FW: A/30/26/PL Highdown Garden Centre, Littlehampton Road, Angmering - MSC2116

Subject: A/30/26/PL Highdown Garden Centre, Littlehampton Road, Angmering - MSC2116

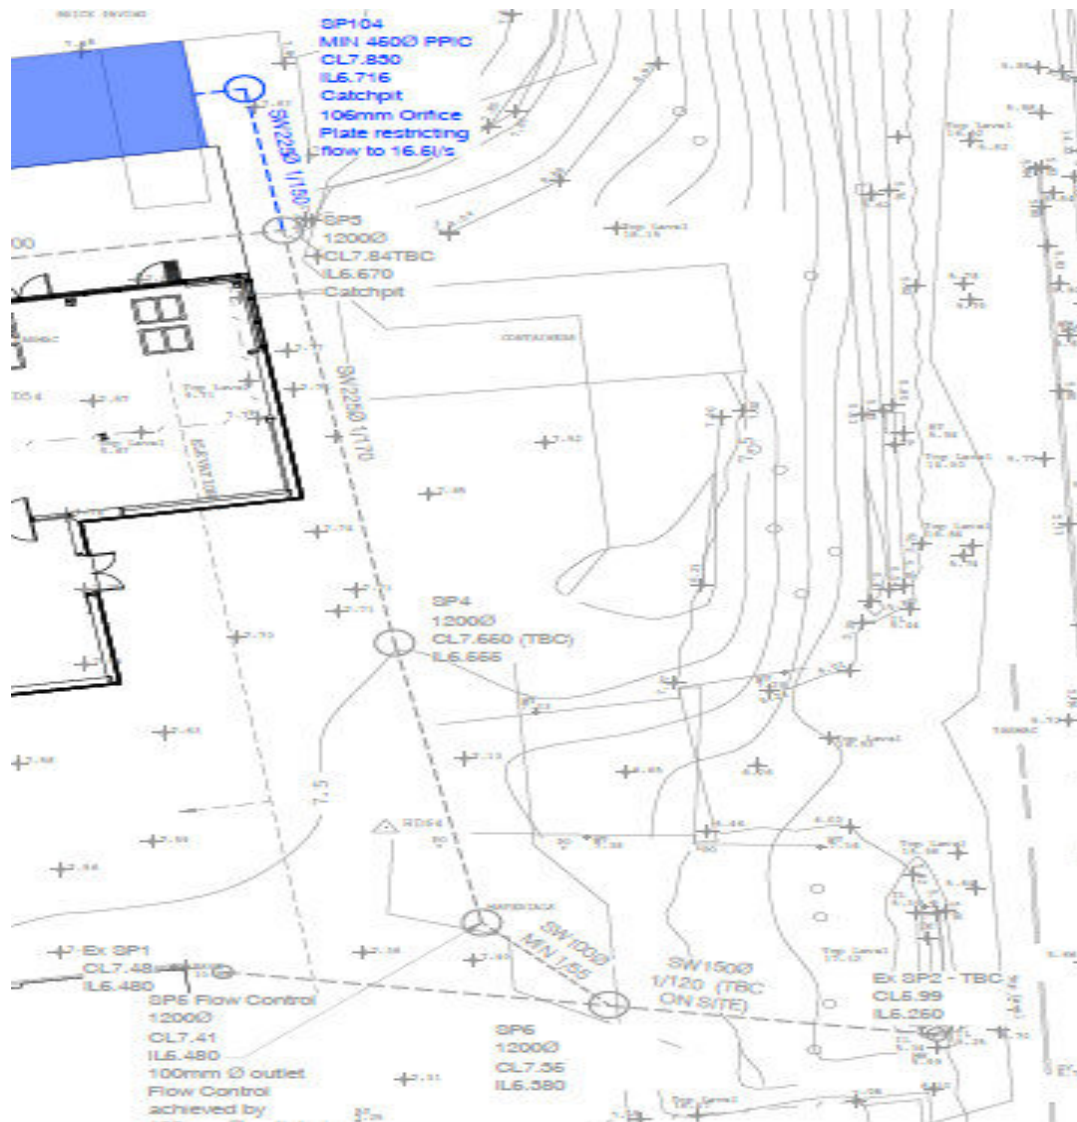
- **Existing drainage system:** Could you provide details of the existing drainage system and the location of the final discharge point? Our engineers will need to ensure it has sufficient capacity.

Drawing 140 already shows the existing surface water drainage run marked in grey (as existing). It runs from SP3 to SP5 (which is already a flow control point) and then through to EX SP2 and the outfall. Have put an abstract below for ease of reference.

As noted in our earlier email the scheme will be an improvement on the current arrangement as the area is currently drained as it is an existing canopy or hard paved sales area and the new scheme will now formally attenuate in a crated system.
